COMMITTEE REPORT

BY THE EXECUTIVE DIRECTOR FOR ECONOMIC GROWTH AND NEIGHBOURHOOD SERVICES
READING BOROUGH COUNCIL
PLANNING APPLICATIONS COMMITTEE: 29 March 2023

App No.: 221563/FUL

Proposals: Proposed demolition of 8 garages and construction of 2 x 3 bedroom residential units.

Proposed Site Plan

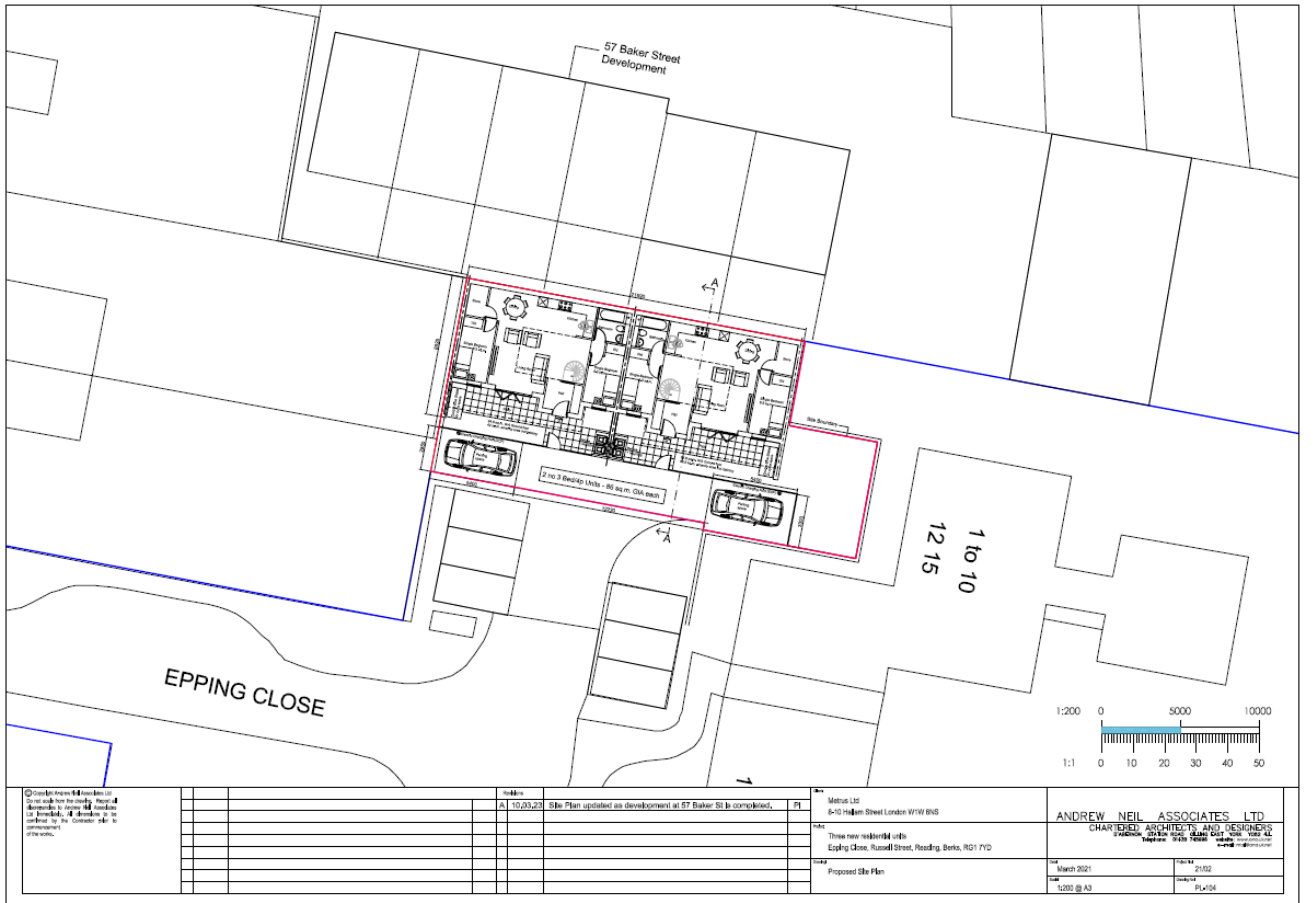
- 7.9 As can be seen from the proposed site plan, the proposed building would be located immediately adjacent the north and west boundary, with no relief, effectively filling the site to its margins such that it would appear cramped and overdeveloped. Whilst indicative soft landscaping is shown, there would be a distinct dominance of built form and hardstanding with little space for meaningful soft landscaping. As a consequence of the siting of the dwellings, the proposed garden areas would be located to the front of the site. This would be out of keeping with the prevailing pattern of development and the need for which is symptomatic of the overdeveloped nature of the site and the consequential introduction of inappropriate design and layout elements.

- 7.36 In accordance with the adopted Parking Standards and Design SPD, the development would require 2 off road parking spaces for each 3 bedroom dwelling. Submitted site plan Drawing PL 104 Rev A only illustrates 1 parking space for each dwelling, which falls short of the Council's Parking Standards. 2 parking spaces would be required for each dwelling to ensure that any overall flow of parking did not impact on the remaining area of parking/garages for residents of the adjacent flats.

Proposed North and South Elevations

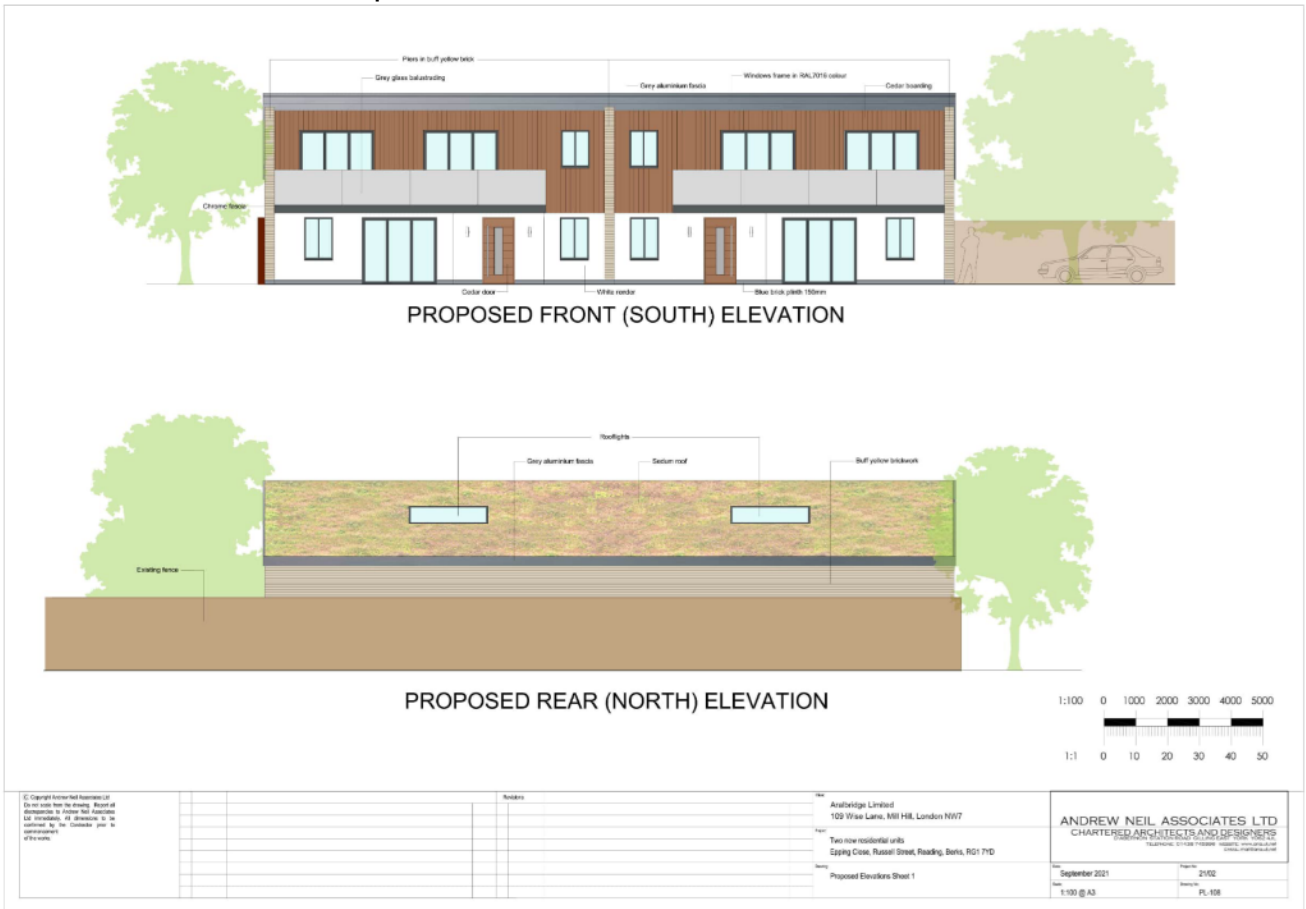
- 7.13 Due to the constraints of the site, the design approach has been forced to fit the site. The side elevations lack architectural detailing, visual interest and refinement, presenting blank elevations which would be unattractive and would have a poor appearance - and to a lesser extent the same with the rear elevations. The need to restrict the height of the building at the rear highlights the awkwardness of the site layout and the incompatibility of the design with the character of the street scene and wider conservation area. The proposed sedum roof could add visual interest to the proposal; however, it would not be a clearly visible element of the scheme when viewed from the front of the site and as discussed elsewhere in this report it is not clear whether its construction would even be possible. In overall terms, the proposed design is considered to offer a bland appearance. The proposed modern materials (glass, vertical timber panelling, zinc fascias) are not considered sufficient in themselves to create a visually interesting building or to mitigate the shortcomings of the fundamentals of the design. The proposal fails to provide replacement-built form of a high quality design and therefore cannot be considered to enhance the character and appearance of the conservation area.

Proposed Ground Floor Plan

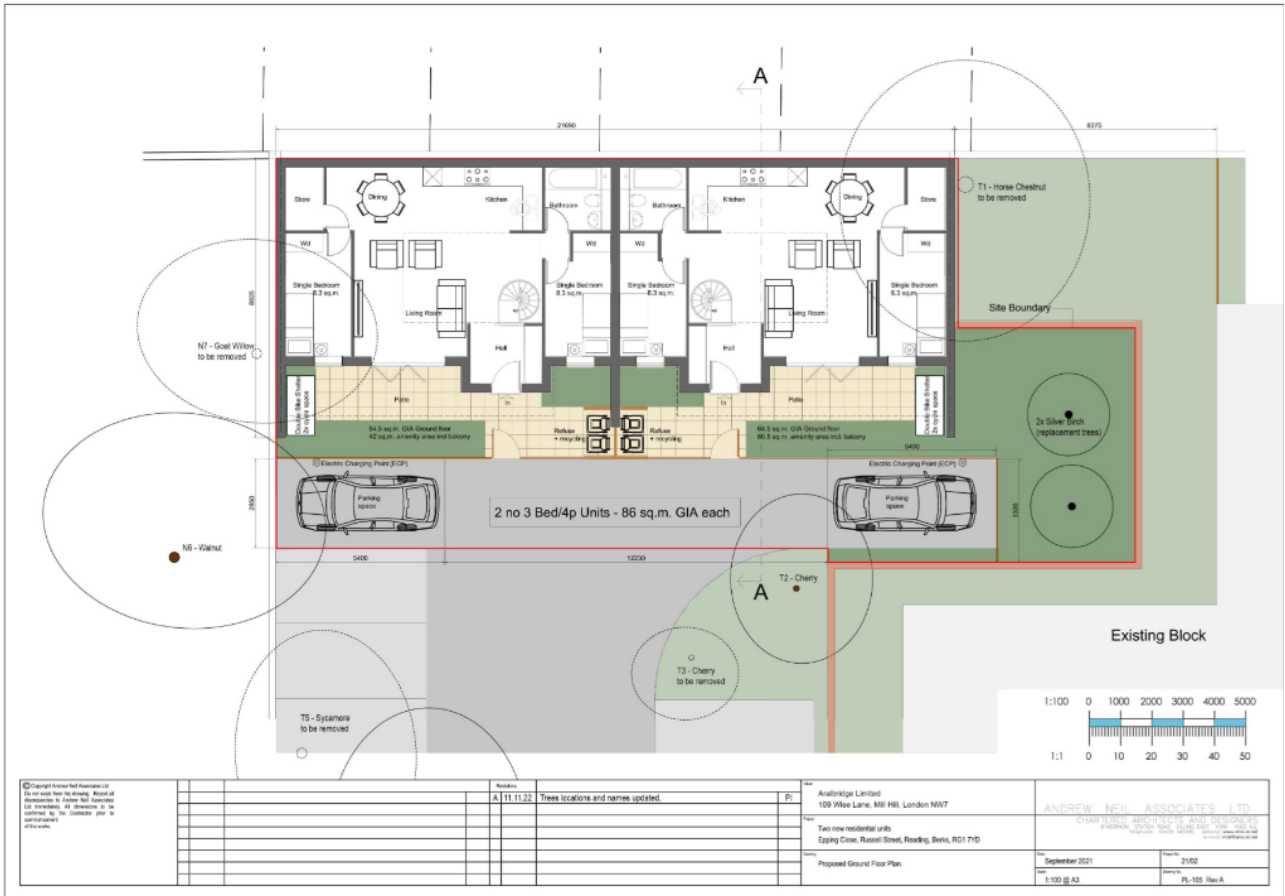
- 7.29 The proposed floor plans indicate that the third bedroom to each dwelling, located at first floor, would have a floorspace of 12.3m. However, given the shallow roof slope, the actual useable floorspace would appear to be considerably less than this, with a significant extent of the space affected by the slope of the roof. The size and roof slope would create an oppressive and confined living space, which as above, would also be compromised by shade from the trees and which would add further harm to the amenity of future occupiers.
- 7.30 It is also noted that the harm to amenity identified above further demonstrate that the proposals would be an overdevelopment of the site. Contrary to Policies CC5, CC8 and H10.

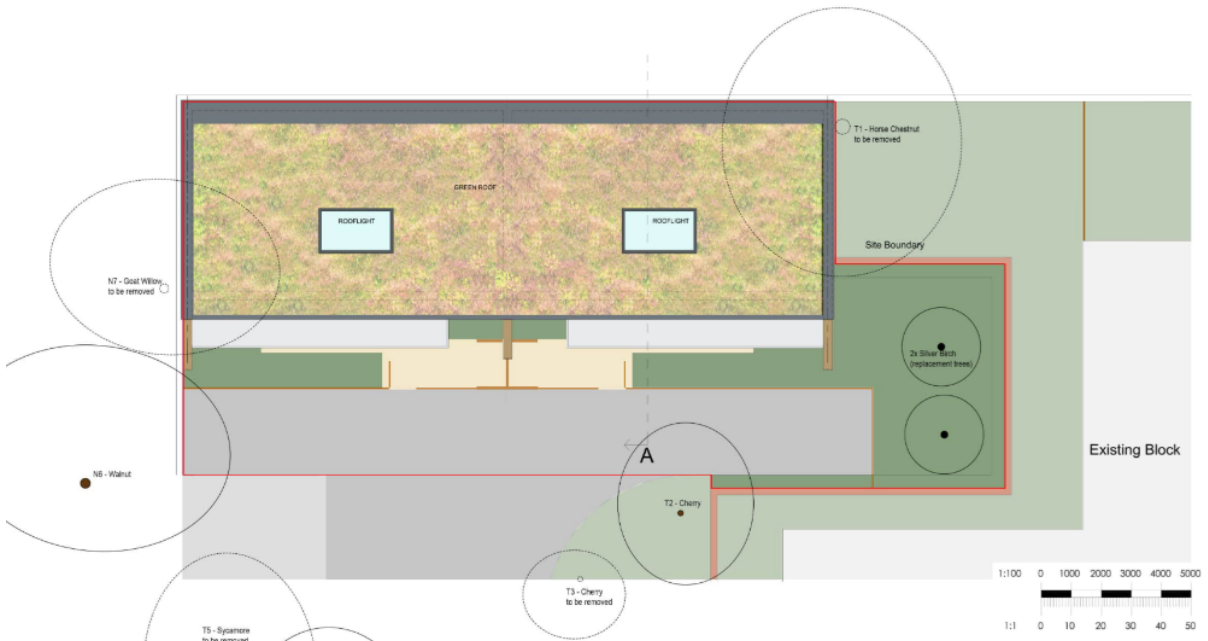
- 7.50 A sedum roof is also proposed, to enhance the biodiversity credentials of the scheme. The Council's Ecologist has confirmed that the sedum roof, proposed on a 1 in 3 gradient, would be unusually steep and the proposed sedum roof may in fact not be feasible. There are no detailed plans or sections through the roof and it is not clear if the building would be strong enough to support the roof proposed. The Council needs to be confident that the sedum roof could actually be installed and deliver the benefits suggested.
